MARK-UP OF SECTION 96 INCLUSIONS

16.07.2015 - 29.07.2016	A	DEVELOPMENT APPLICATION ISSUE SECTION 96 ISSUE	Morris Goding Elisa Moechar Phone: 9692 8000 Email: elisa@mgac.com.au	MDA Australia Damon Bissell Phone: 400 444 410 Email: damon@mda-aust.com.au	Chris Medland Phone: 9437 4611 Email: chris@medlandmetropolis.com.au	Brian Clarke Phone: 9437 4611 Email: brian@wilkinsonmurray.com.au	Tony Henslip Phone: 9211 7777 Email: tony@tmplg.com.au	Glenn Dixon Phone: 9332 3601 Email: glenn@360.net.au	WENONA SCHOOL 176 Walker Street, North Sydney NSW 2060 Phone: 9409 4406 Email: hmckenzie@wenona.nsw.edu.au	WENONA PROJECT ARCHEMEDES 255-265 Miller Street, North Sydney NSW 2060 PROJECT NO : 14010	Tonkin Zulaikha Greer Architects 117 Reservoir Street ABN: 4600272349 P: (02) 9215 4900 F: (02) 9215 4901 EMAIL: matilda@tztg.com.au WEB www.tztg.com.au	LEVEL 6 PLAN SCALES 1:100 @A1 PHASE SECTION 96 DRAWING NO A-1008 REVISION A	ABN, AVDB, JH, MW, SB, SD, CW CHECKED PT

16.07.2015 - 29.07.2016	A	DEVELOPMENT APPLICATION ISSUE SECTION 96 ISSUE	Do not scale off drawings. Use figured dimensions only. Report any discrepancies to the architect. These designs, plans, specifications and the copyright therein a

------------------------------------	----------	---	---	---	---	--	--	--	--	--	--	---	--	---

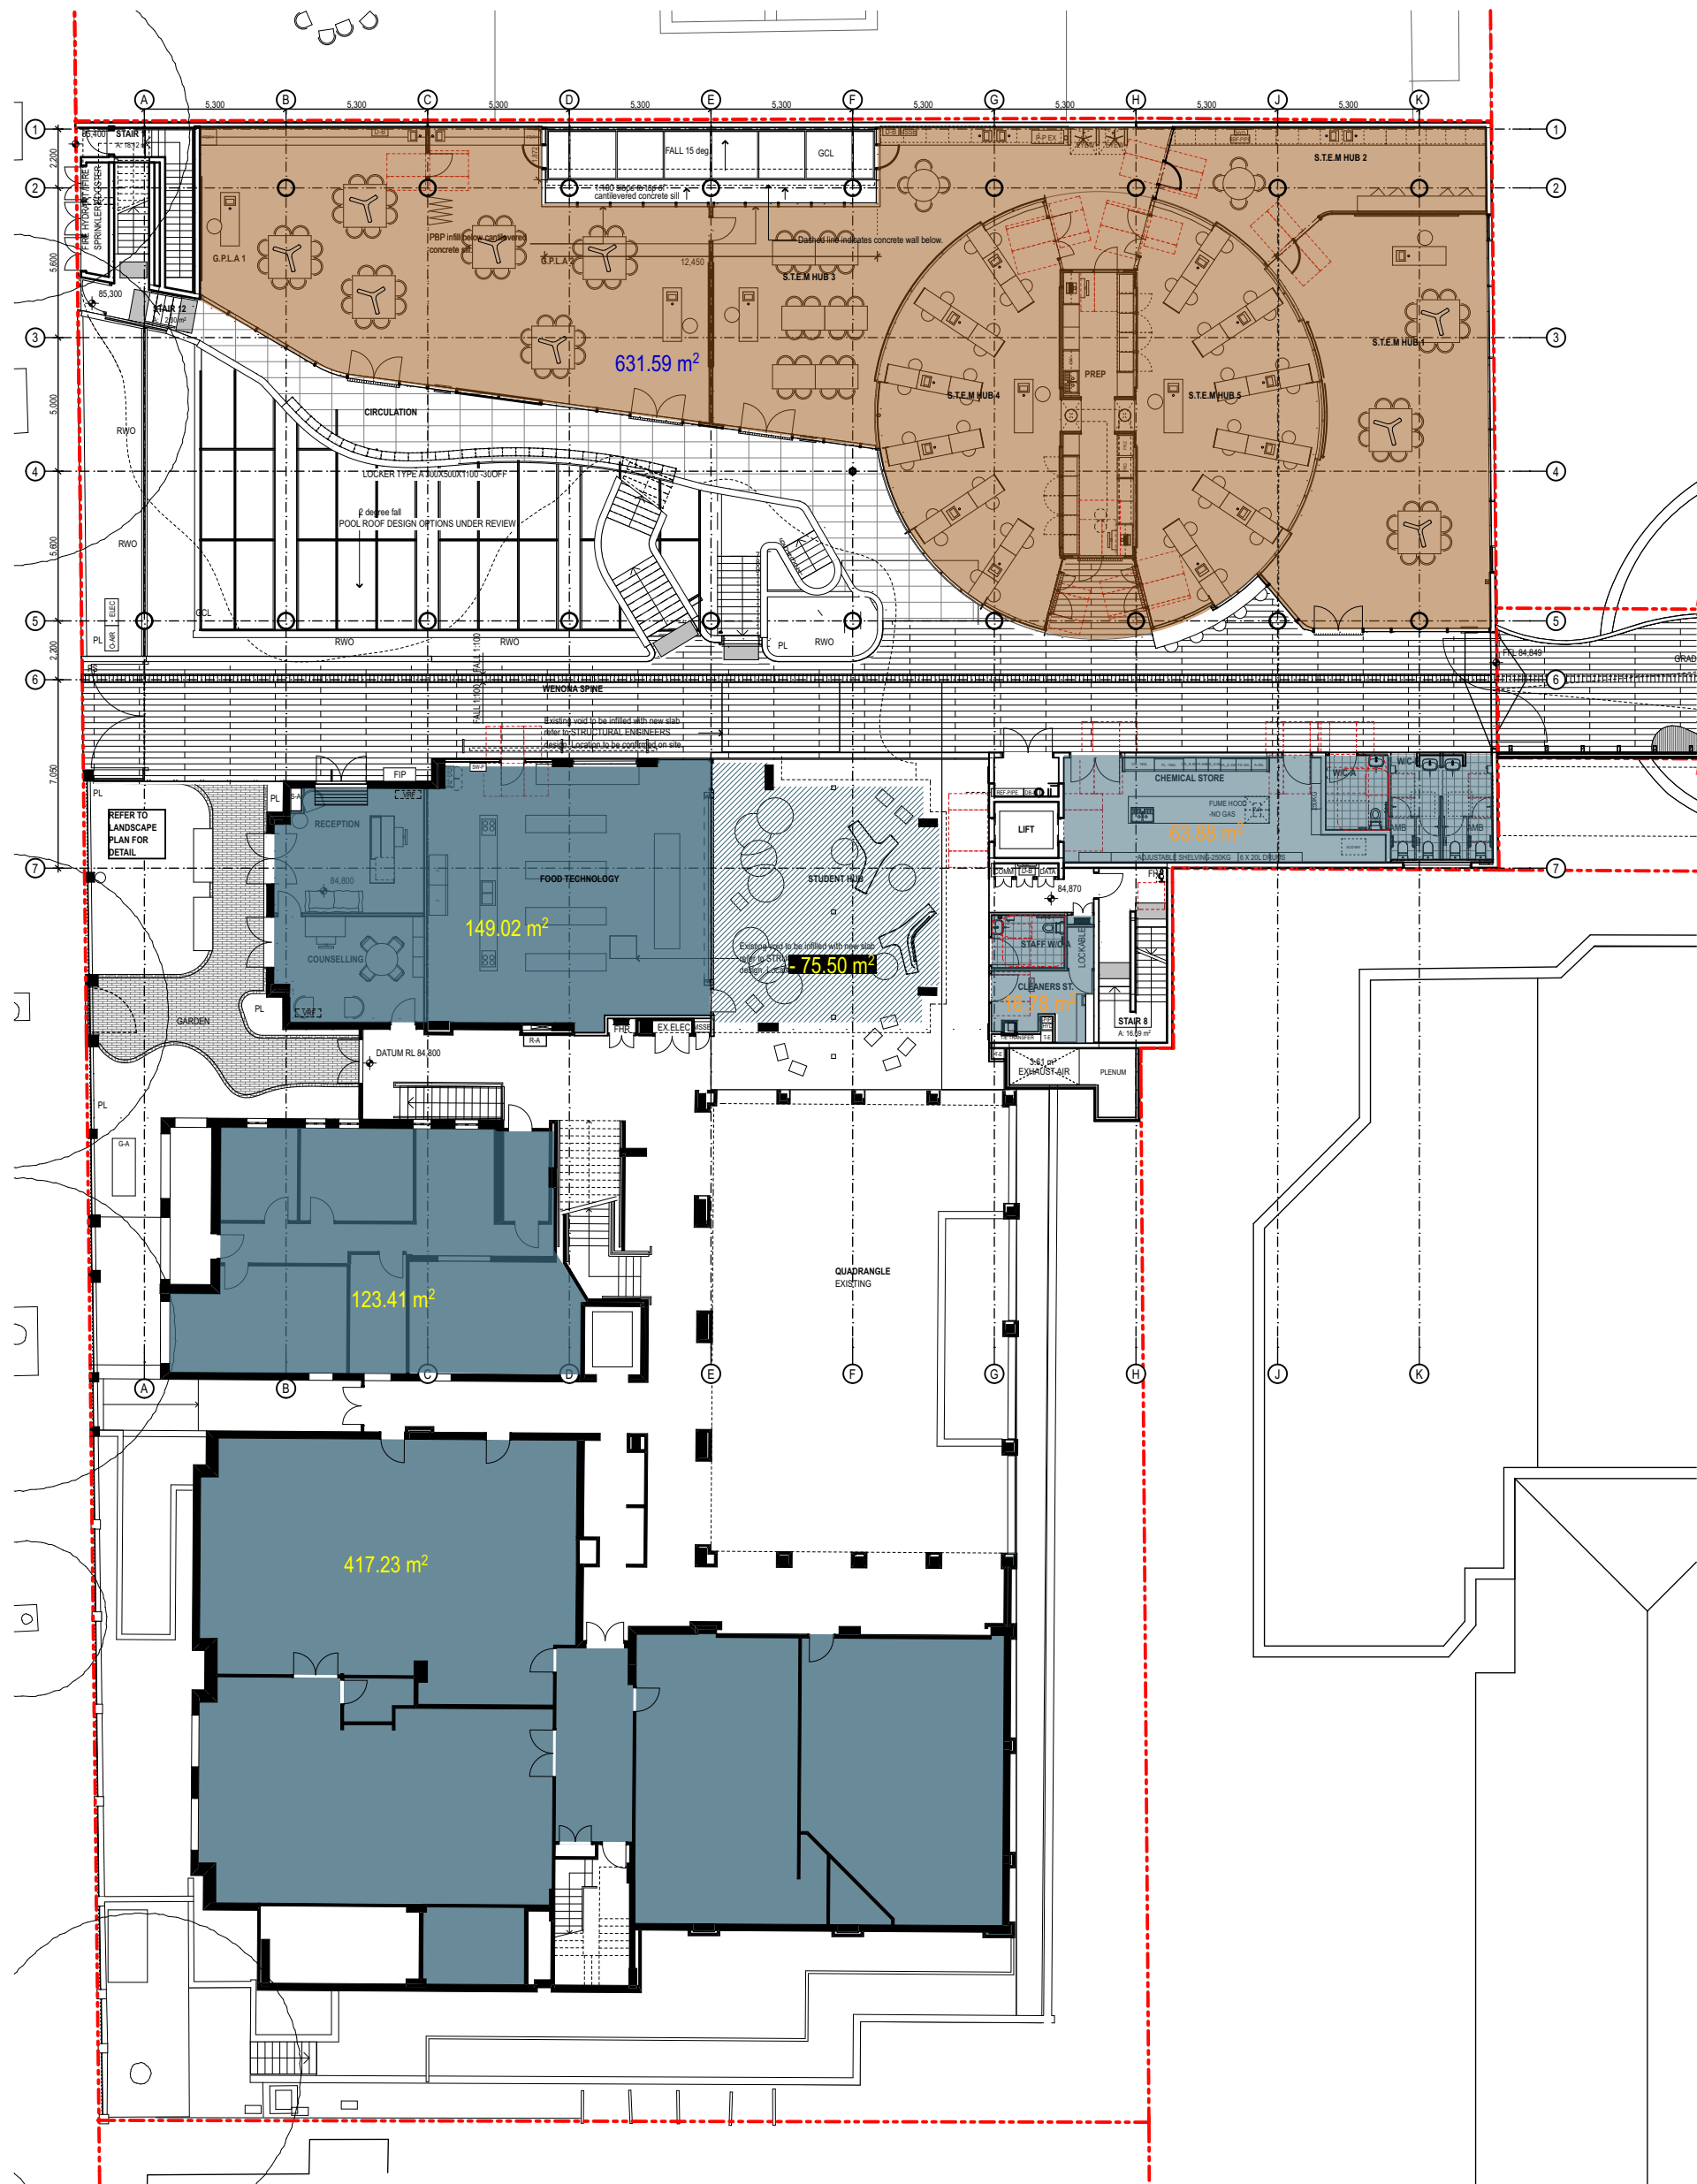
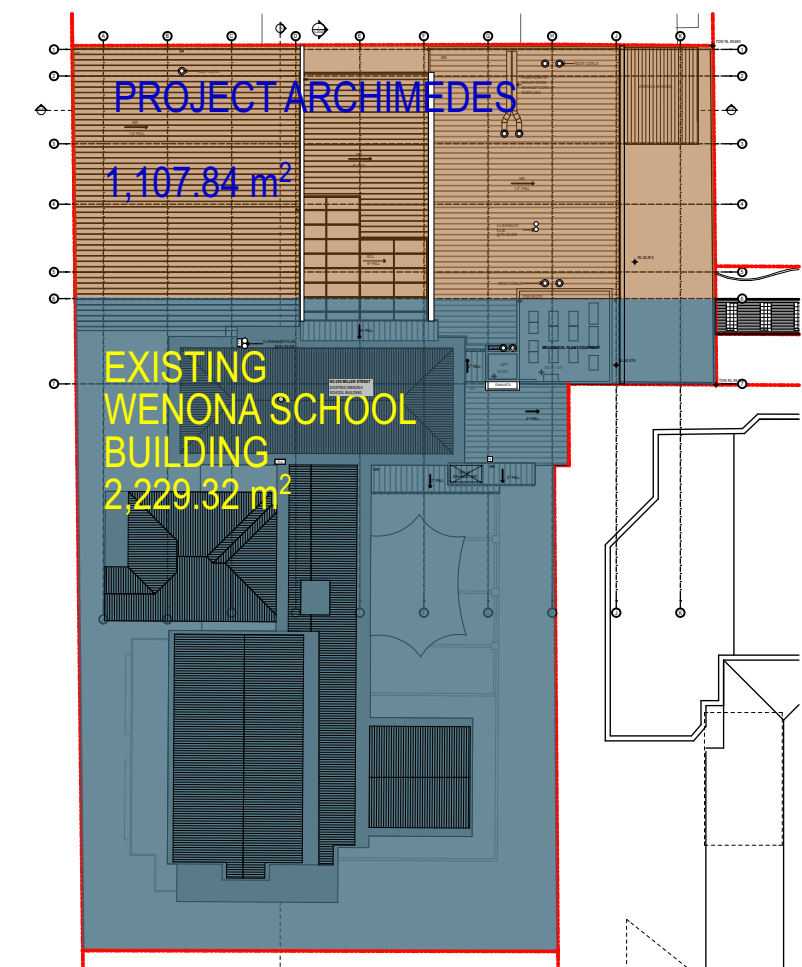
6 GFA/FSR Modification
